Subject: **TRAP - TO - COMB SWITCH-OVER
 RESPONSE**

Model: **BKM-25P/26M**

Serial No: **2,000,401–2,000,450 (BKM-25P)**
2,000,021–2,000,030 (BKM-26M)

Figure 1

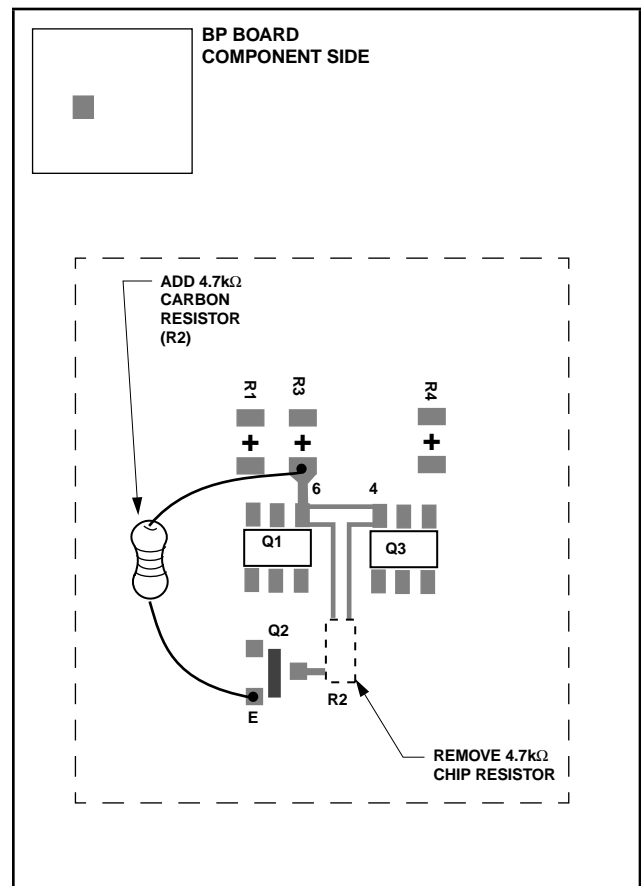
1. Remove R2 (4.7kΩ chip, zone D-10).
2. Solder 4.7kΩ carbon resistor between Q1 pin 6 (or Q3 pin 4) and Q2 emitter. (See Figure 1.)

Figure 2

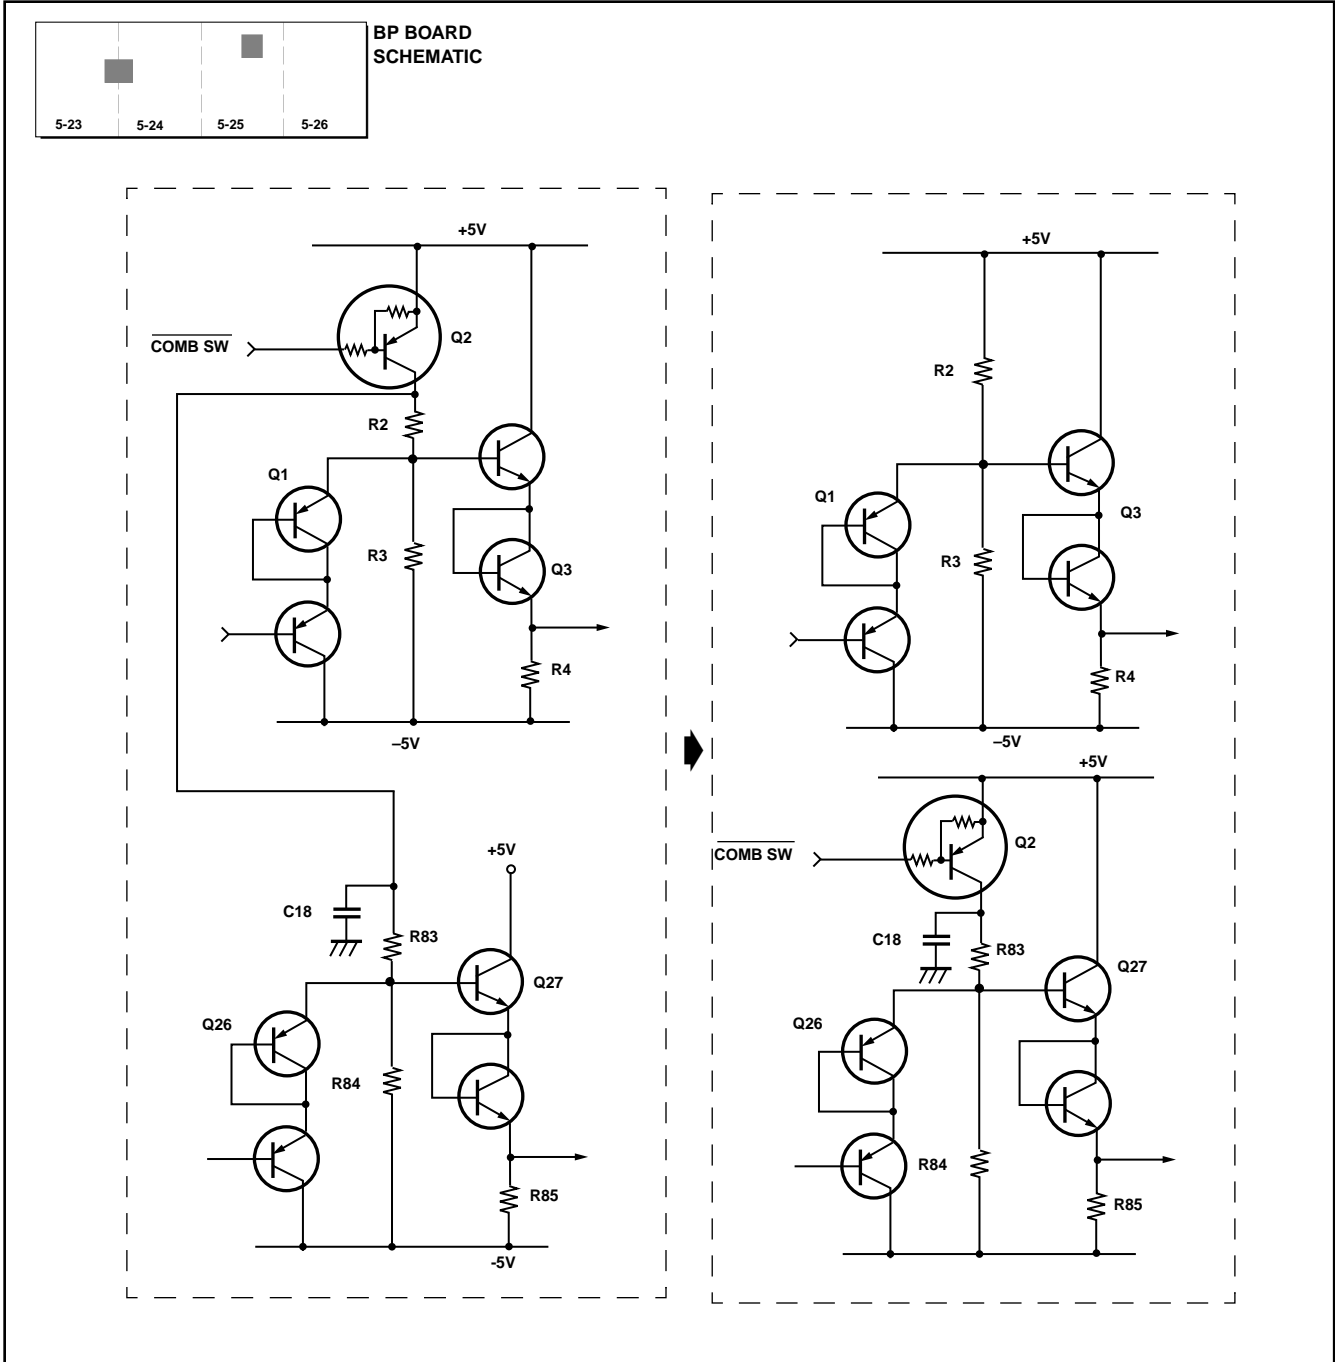
To resolve this condition, perform the following modification procedure. This will remove input switch circuit from the comb circuit. Only the buffer will remain.

Schematic changes are shown in Figure 2.
